UTILITY CONFORMANCE LETTER

Subject: Overland Ranch Filing 2 – Utility Conformance Letter

Aurora Water comments by Iman Ghazali (ighazali@auroragov.org)

OVERALL
UTILITY
PLAN
43 OF 95

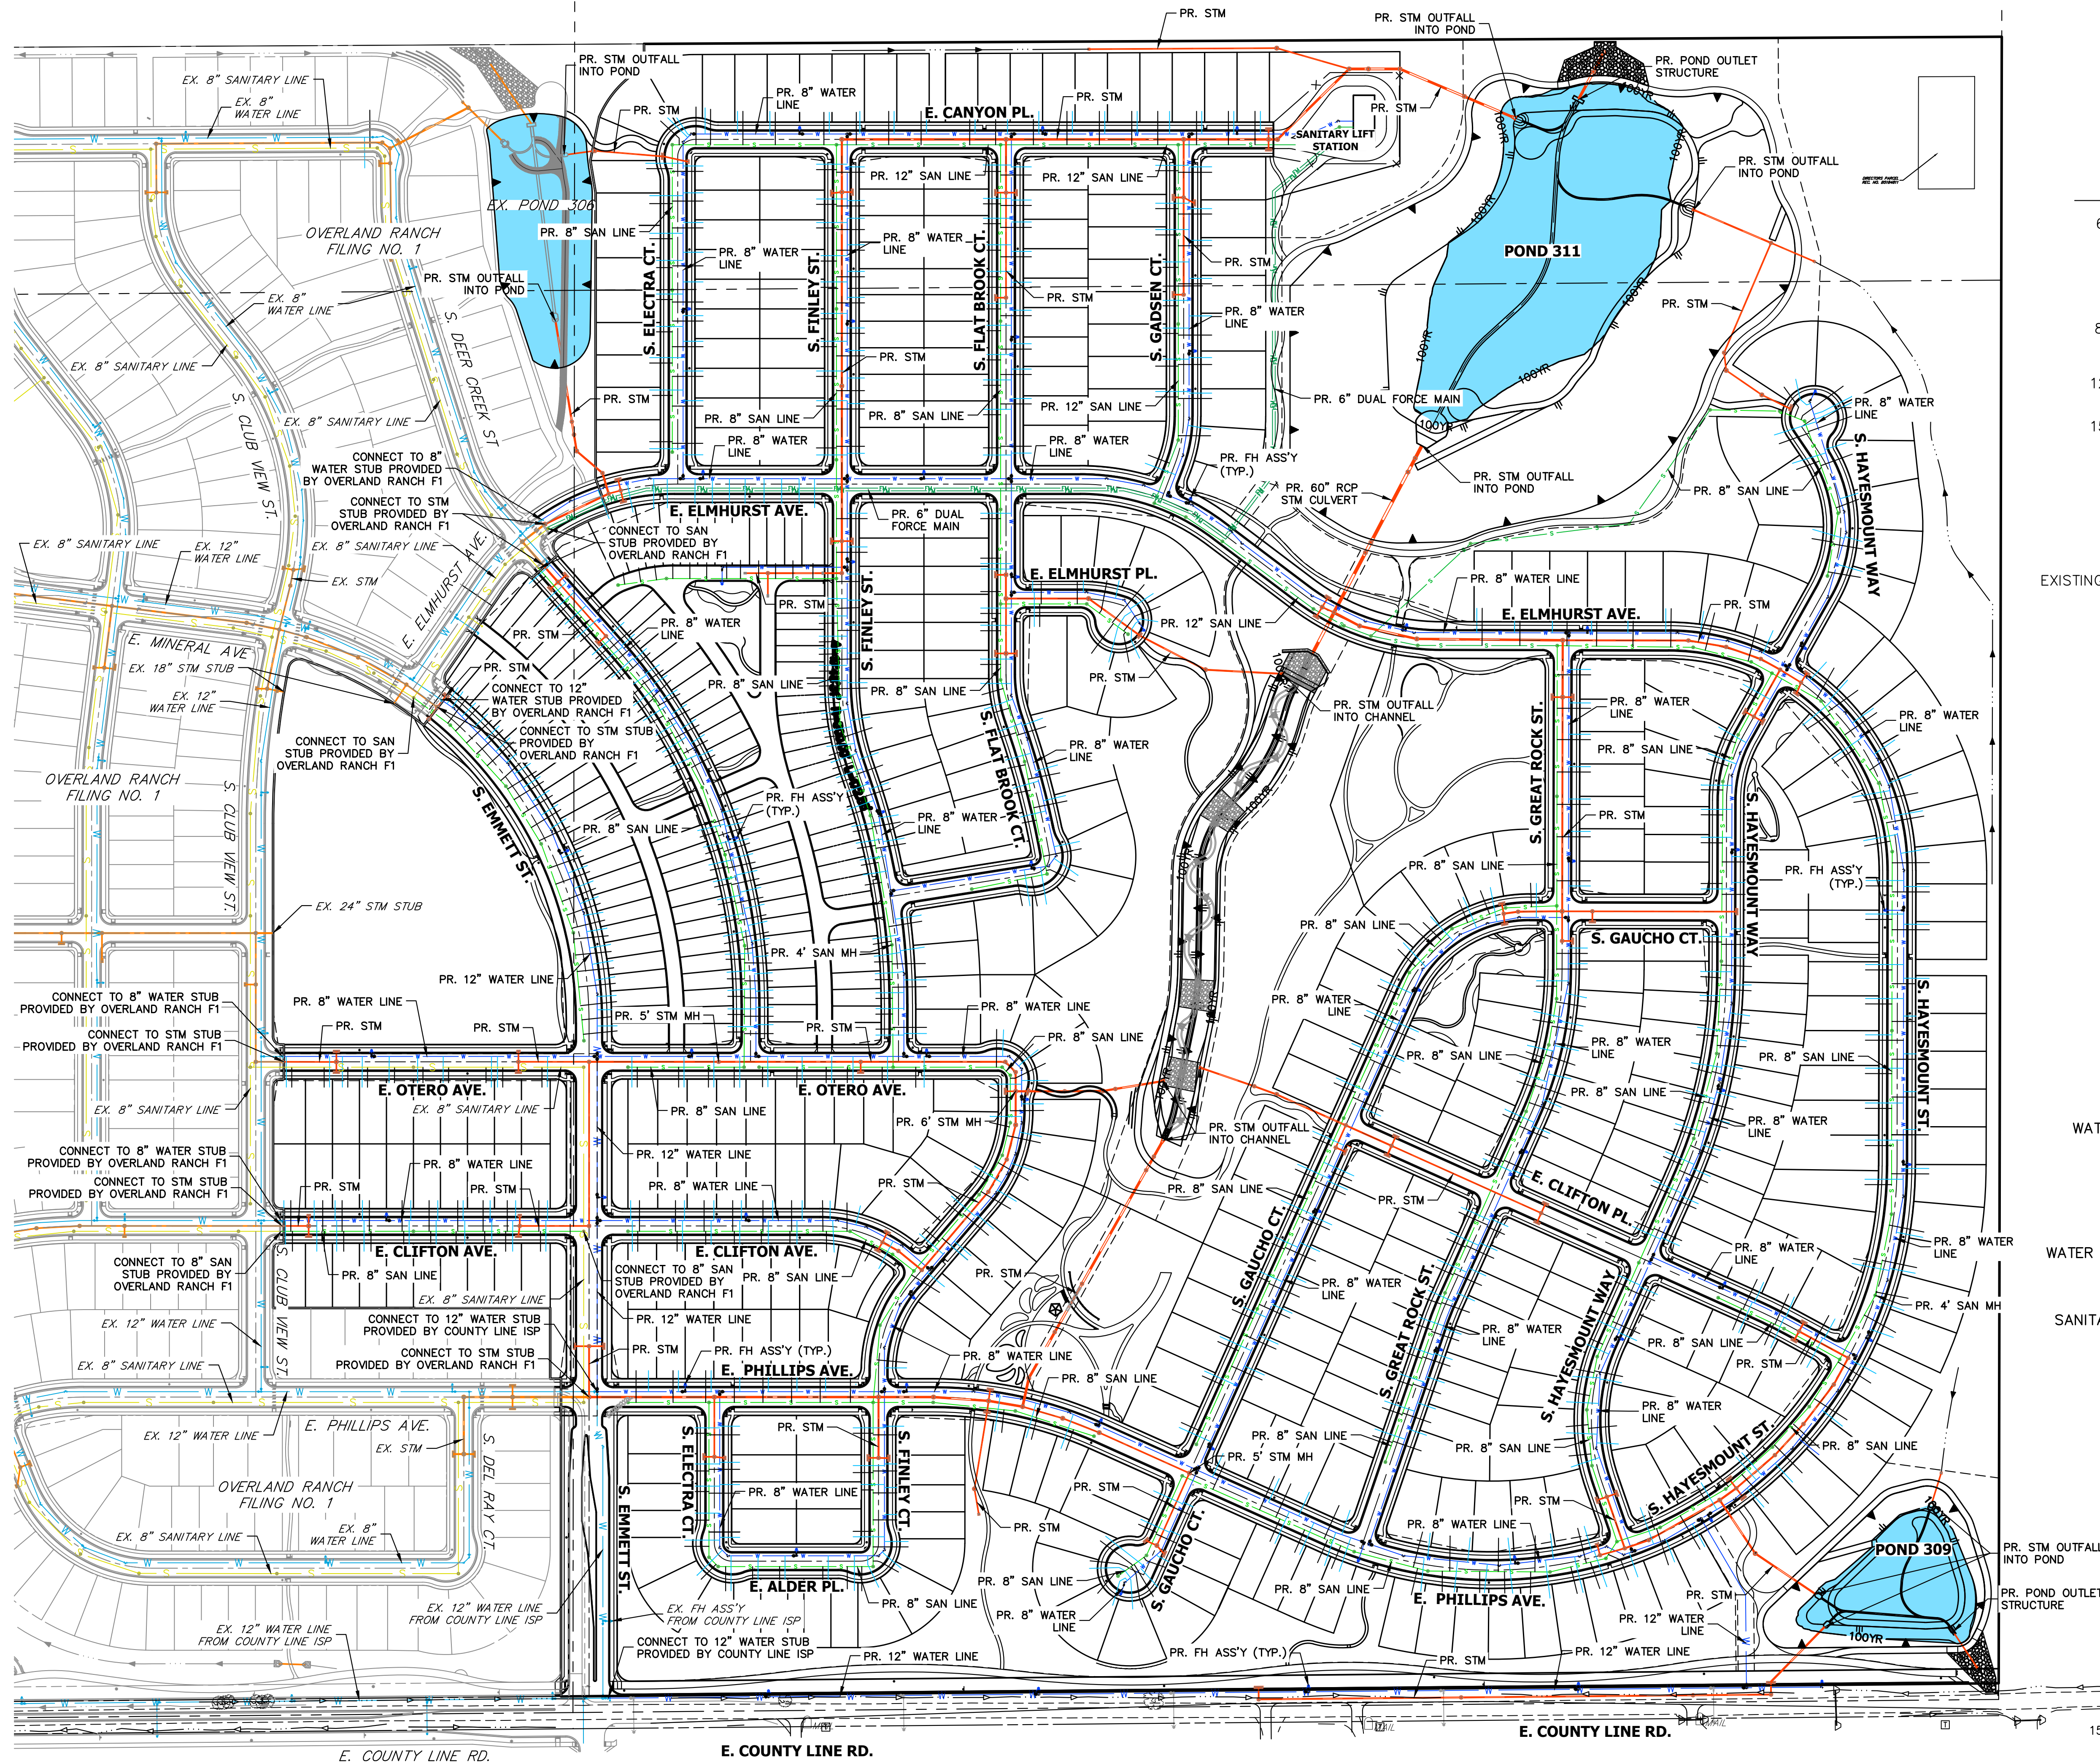
MUS shows 1036 units

Updated to 1036
